DEVELOPMENT REVIEW BOARD
SUPPLEMENTAL SUBMITTAL

PROJECT NO. PR-2021-005467
Application No. SI-2022-00861

Re: Raising Cane's (4800 Montgomery Blvd NE) PR-2021-005467

Please find the following responses addressing comments received in a letter dated May 4, 2022 from the One Albuquerque Planning:

C5.0

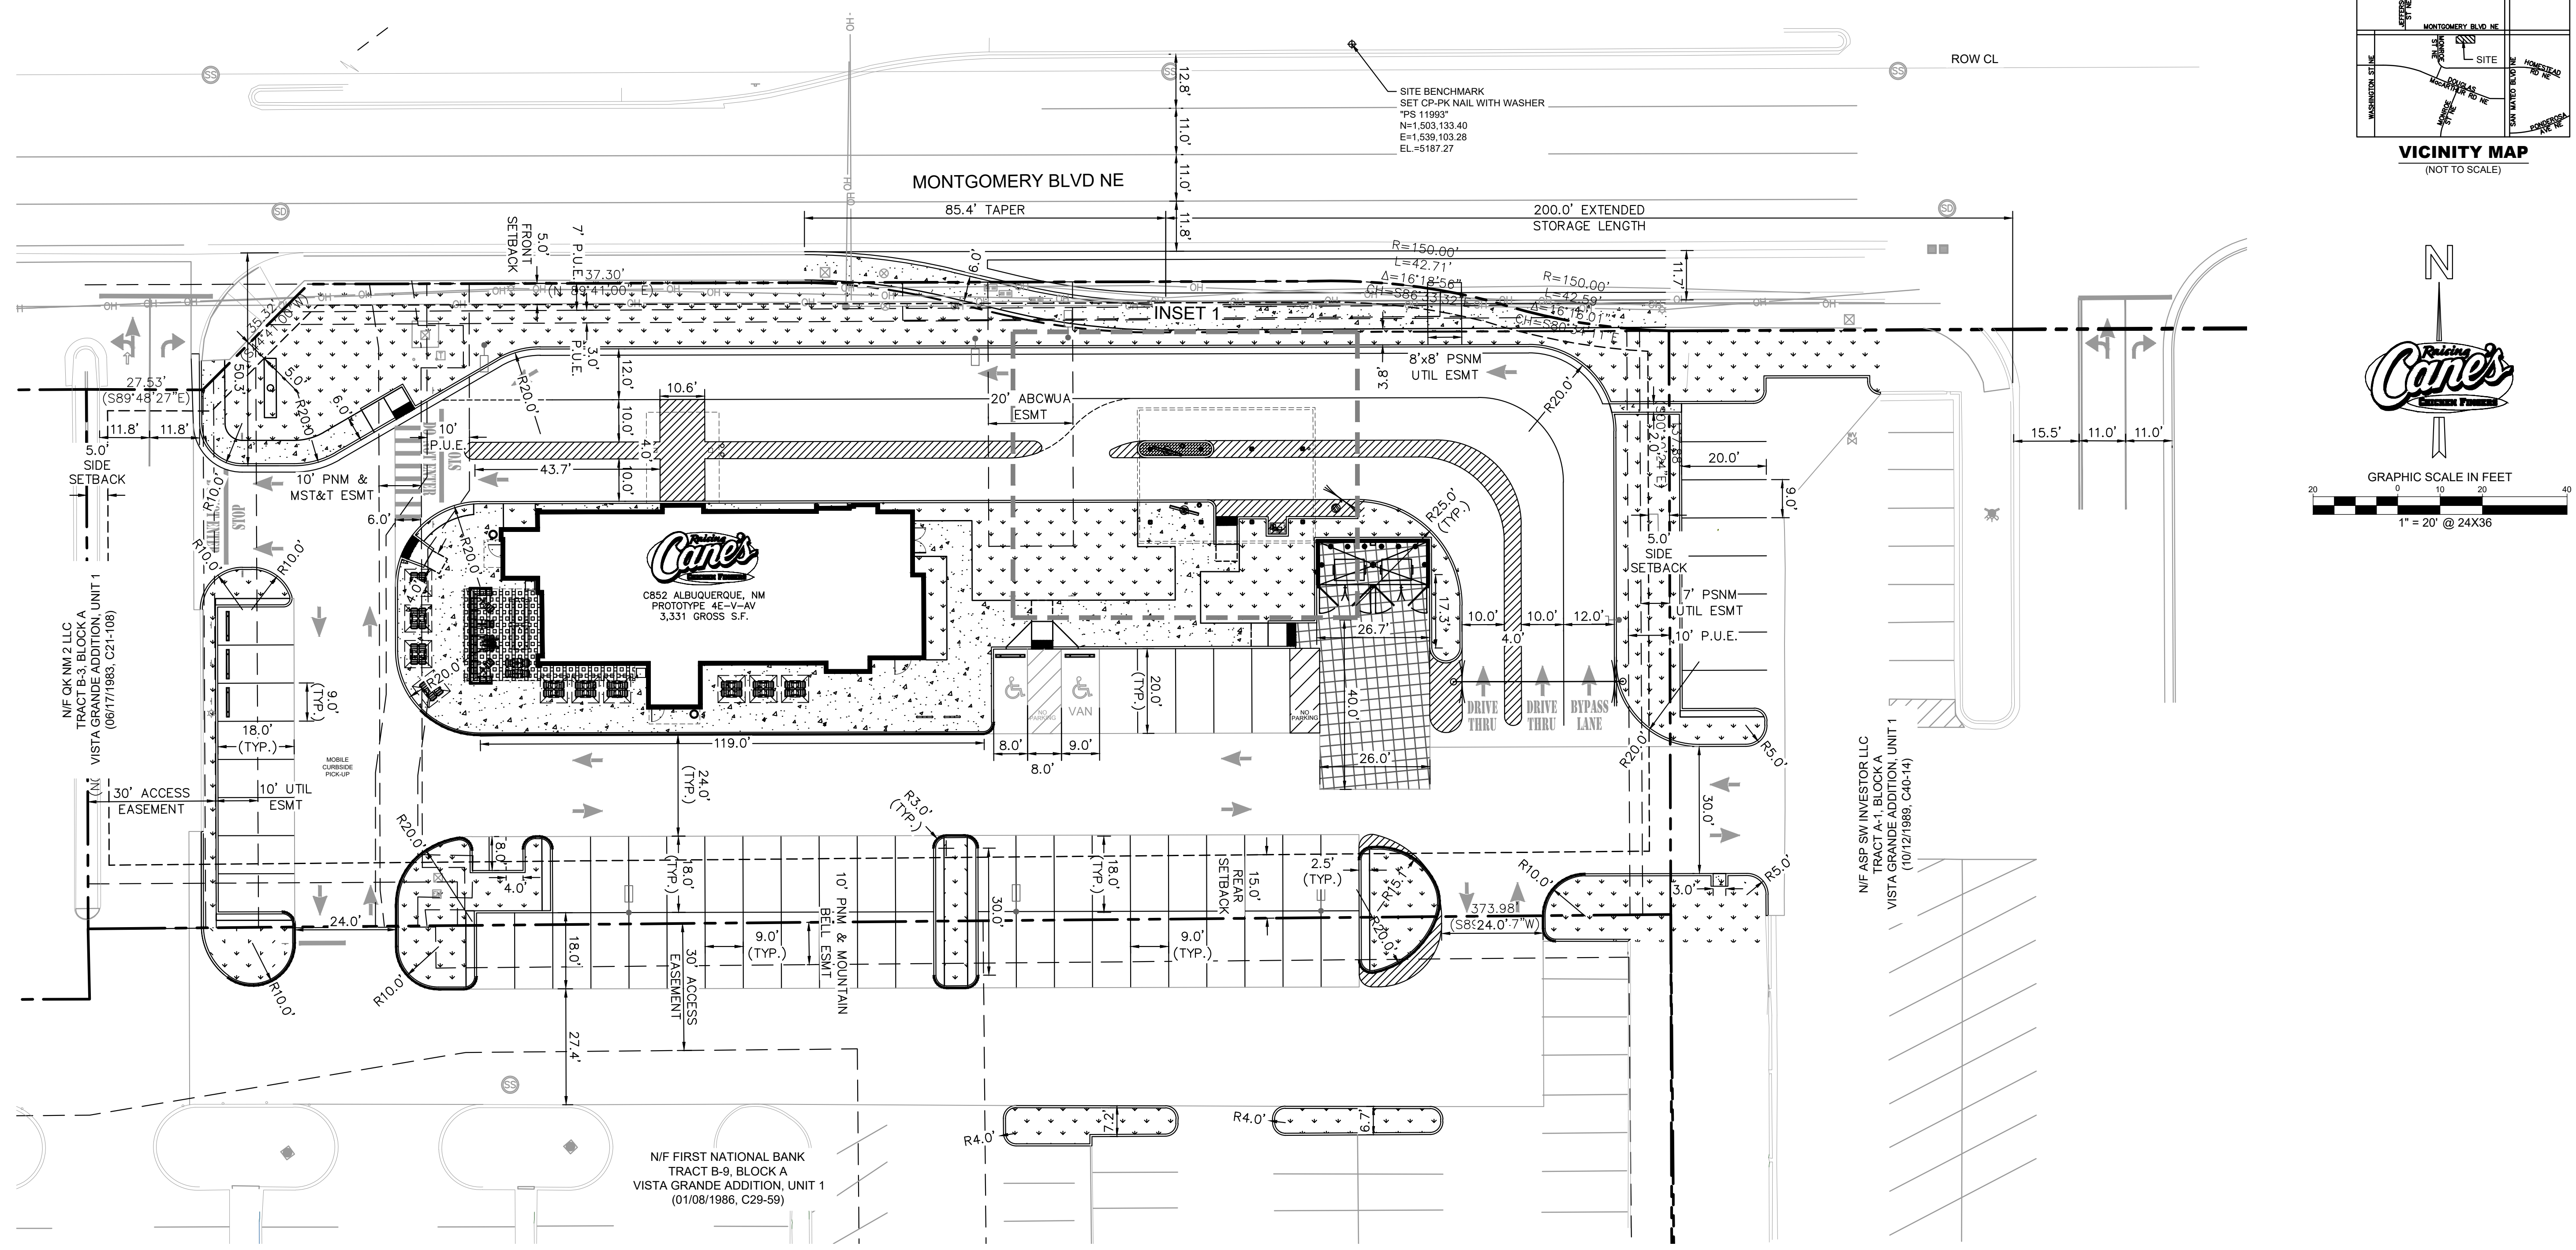
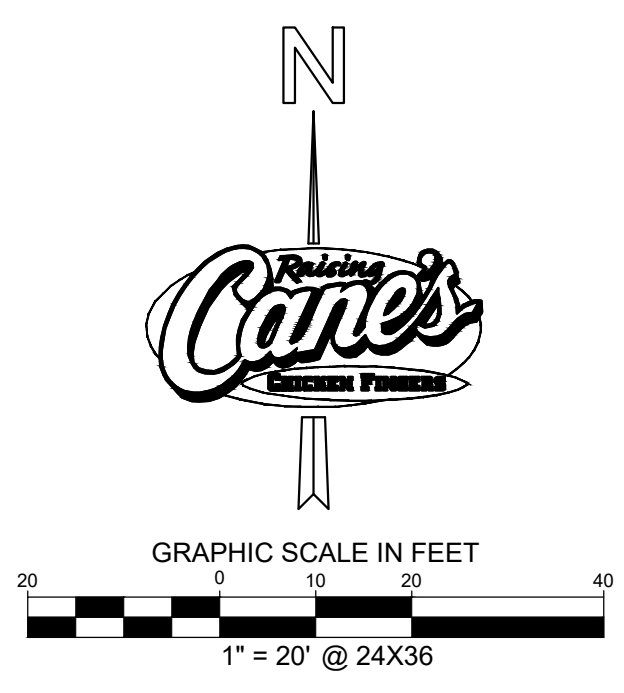
Comment 1: Signature blocks for DRB members and Solid Waste must be added to the Site

Comment 2: The project and application numbers must be added to the Site Plan

Comment 3: On separate sheet, show queue for the drive-thru at 20-foot lengths.

Comment 8: Show clear sight triangles along with the standard note on landscape height restrictions. Use intersection clear sight distance along Montgomery Blvd. Specify on both site plan and landscaping plan

Response 1: Comment addressed, see sheet C5.0 – Site Keynote Plan.

Response 2: Comment addressed in C5.0 Keynote Plan.

Response 3: Comment noted, see sheet C5.0 – Site Keynote Plan.

Response 8: Comment noted, see sheet C5.0 – Site Keynote Plan.

C5.1

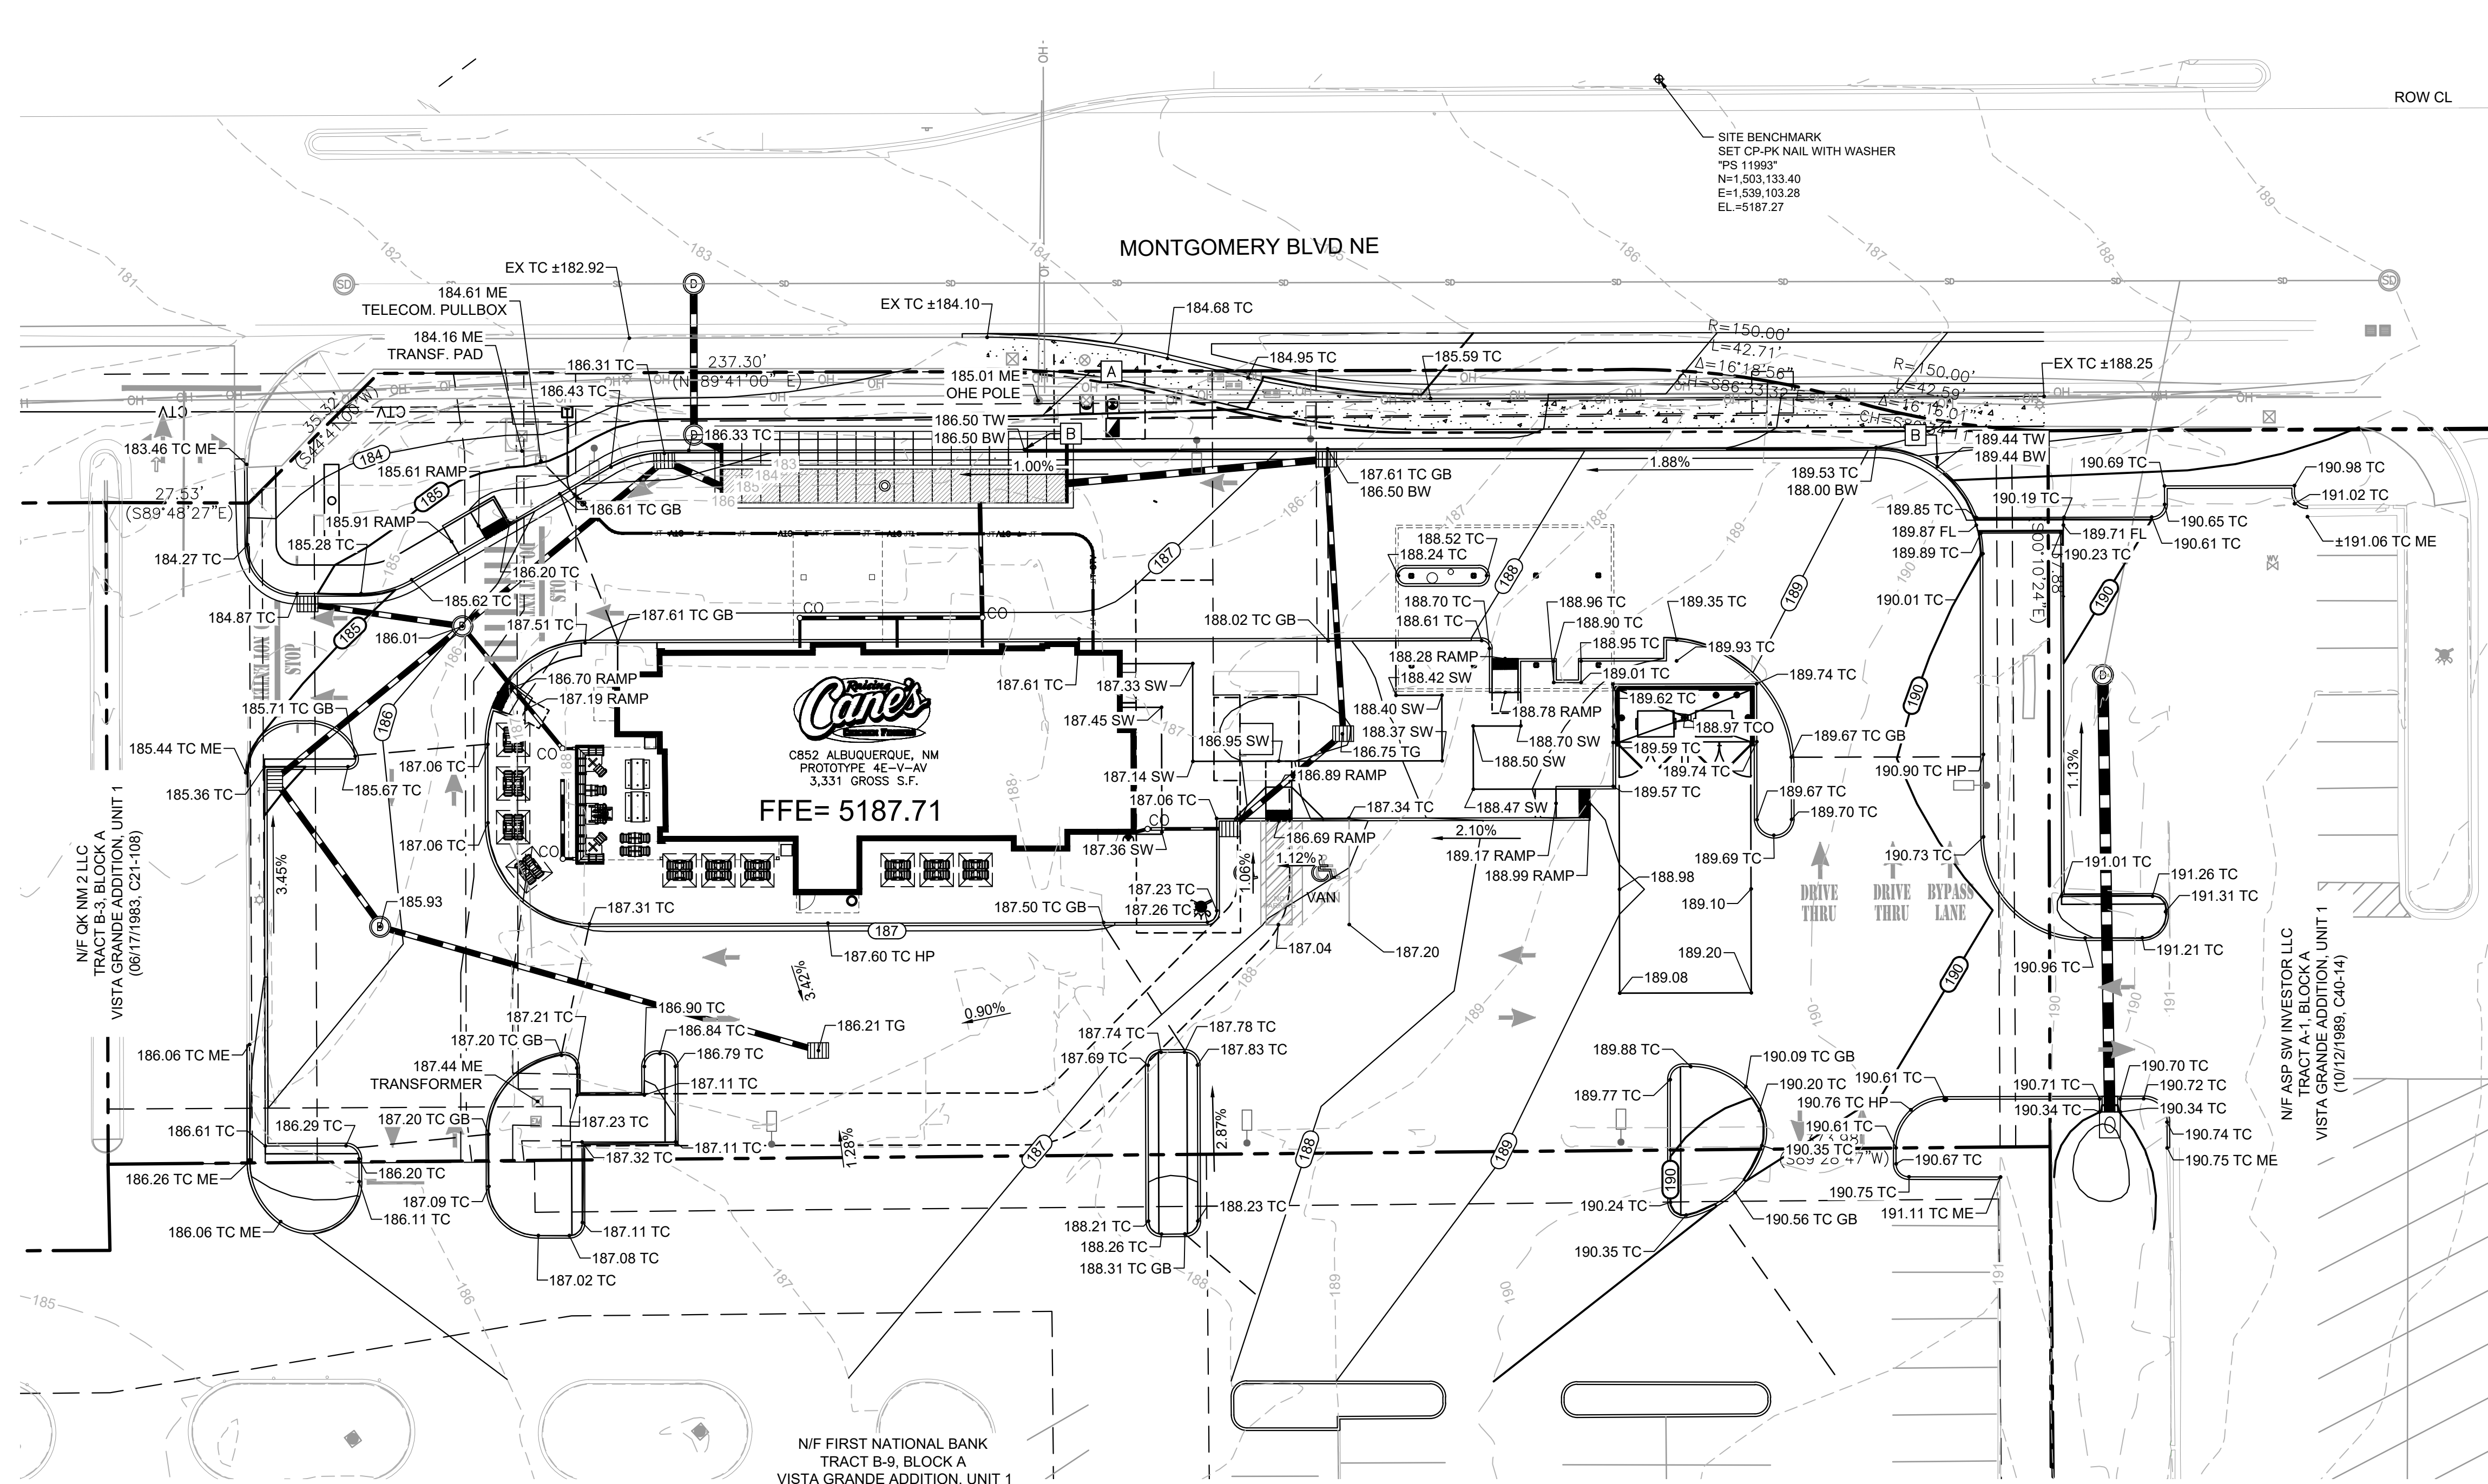
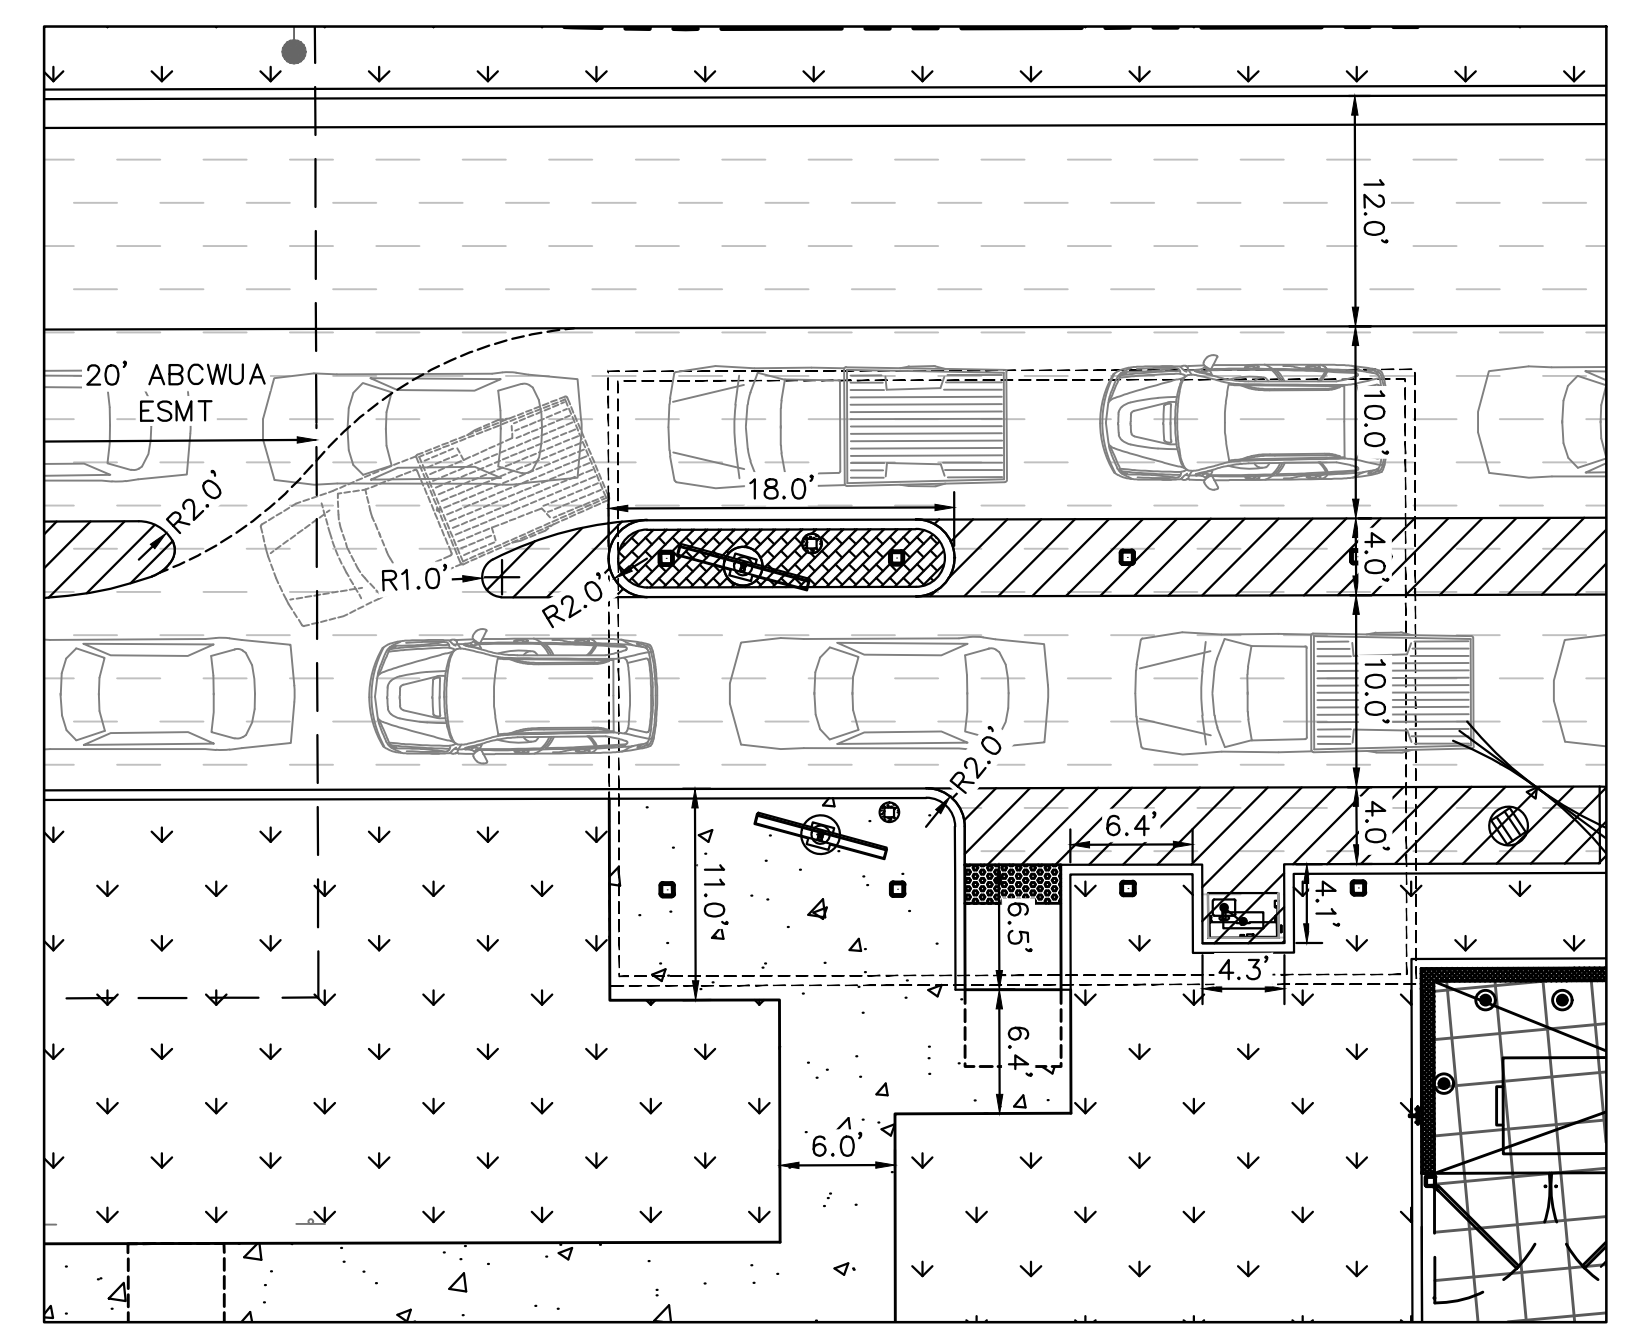
Comment 4: Freestanding Pylon Sign must be located at least 3 feet from property line (not indicated on site plan), as per IDO section 5-1(G), Table 5-1-4.

Comment 5: At least one 8-foot-wide van accessible aisle is needed for the handicapped spaces.

Response 4: Comment addressed in sheet C5.1 - Dimensional Control Plan.

Response 5: Comment addressed. Updates can be found in sheet C5.1 Dimensional Control Plan

C8.0

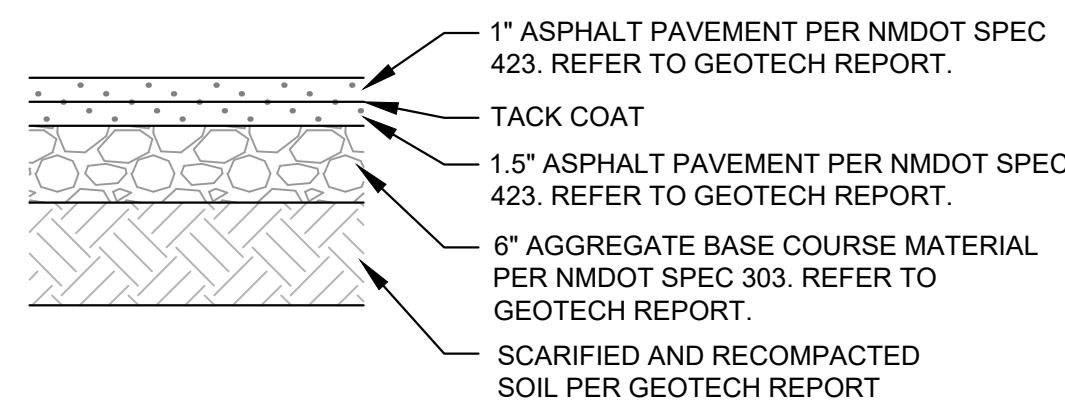
Comment 3: Note that the fireline connection will be required to be a dry-tap. We do not allow wet-taps for 6-inch services onto 6-inch mains.

Comment 5: Exclusive public water and sanitary sewer easements are required for all public lines that are to be constructed outside of any dedicated rights-of-way. Easements for standard sized water meters need to be 5'x5' and include the length of the water service if located on private property.

Response 3: Comment addressed in the Note 16 in C8.0 Utility Plan.

Response 5: Comment addressed in C8.0 Utility Plan.

BARRIER FREE RAMP DETAIL
N.T.S.

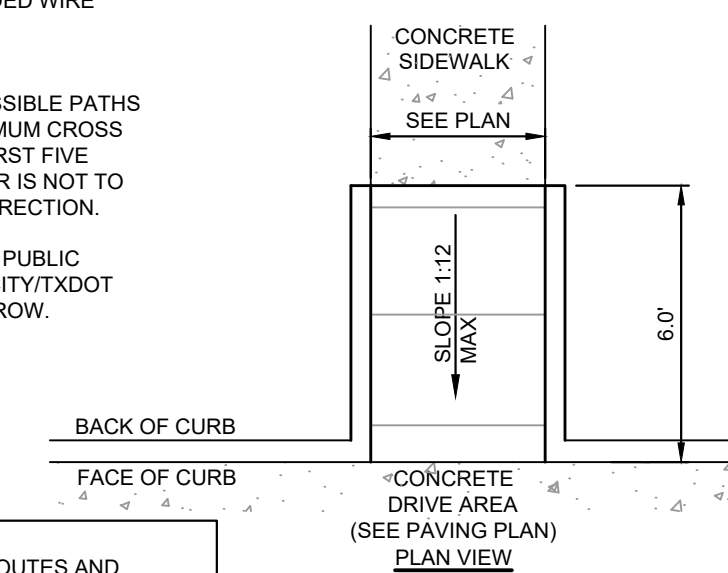
Comment 4: Use exact detail for graphics of ramps on site plan. Specify header curb, minimum landing area, etc.

Response 4: Comment noted. All ramps have been called out with City of Albuquerque ramp details.
